IREDELL COUNTY HEALTH DEPARTMENT

Statesville Office (704) 878-5305 Mooresville Office (704) 660-3625 PERMIT # 207849

IMPROVEMENT PERMIT / AUTHORIZATION TO CONSTRUCT / OPERATION PERMIT / EXISTING SYSTEM

SITE ADDRESS: 114 Bells Run Court Mooresville NC 28117 PHONE: (704) 847 4648 (704) 619 9187 ALT. PHONE: (704) 345 3711 Scott Rodeville (owner)

INITIAL SITE SKETCH

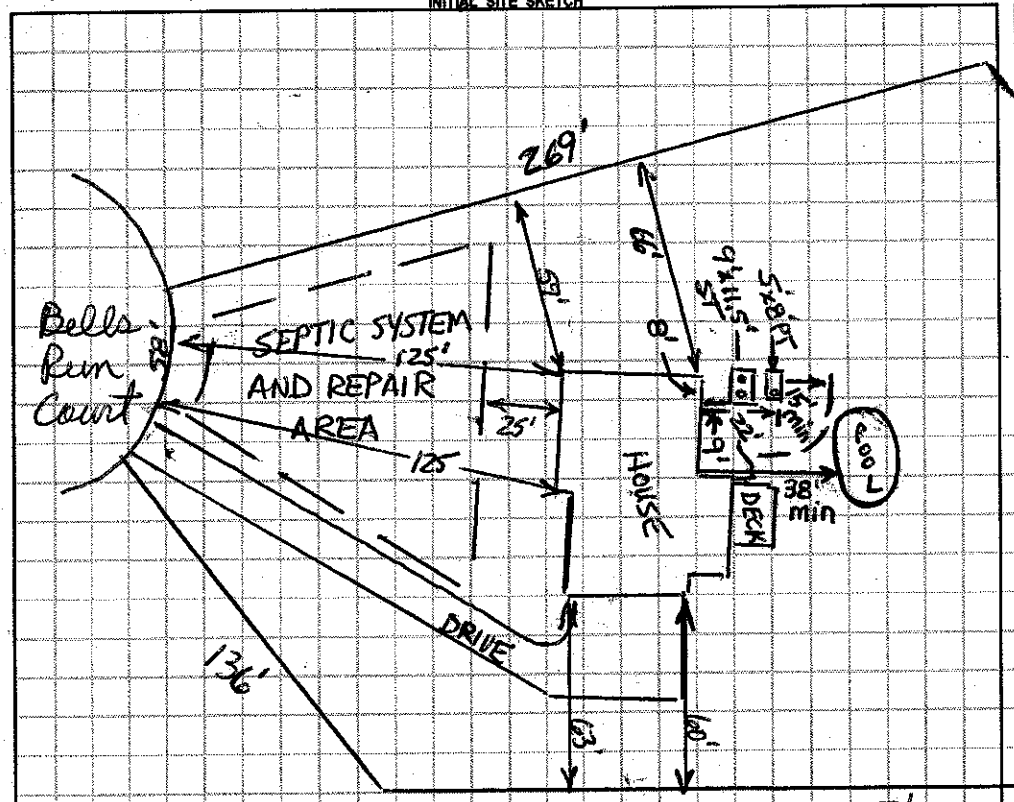
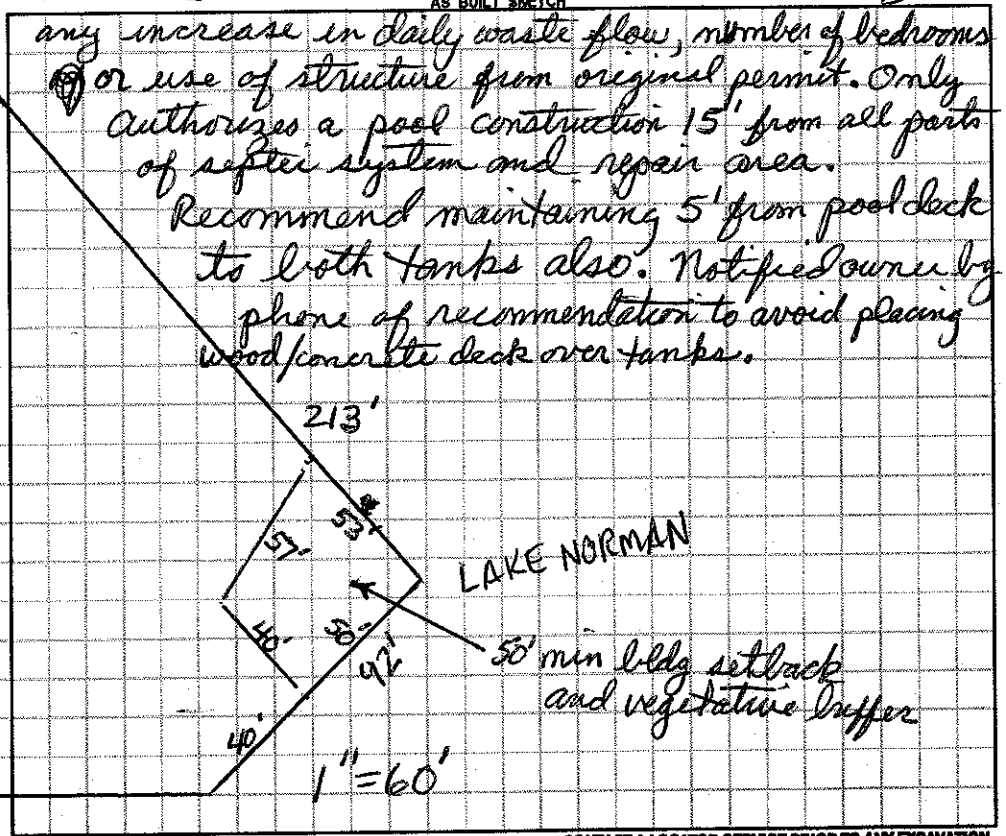
Comments / Conditions: Pool location as shown on site plan is too close to the pump tank. Septic tank and pump tank were located and flagged w/red flags and 15' minimum set back from the tanks was marked with white flags. Edge of pump tank is 22' from back wall of house. With 15' bldg setback to pool the minimum distance from pool to house is 37'. 40' is recommended. This authorization does not authorize any increase in daily waste flow, number of bedrooms or use of structure from original permit. Only authorizes a pool construction 15' from all parts of septic system and repair area. Recommend maintaining 5' from pool deck to both tanks also. Notified owner by phone of recommendation to avoid placing wood/concrete deck over tanks.
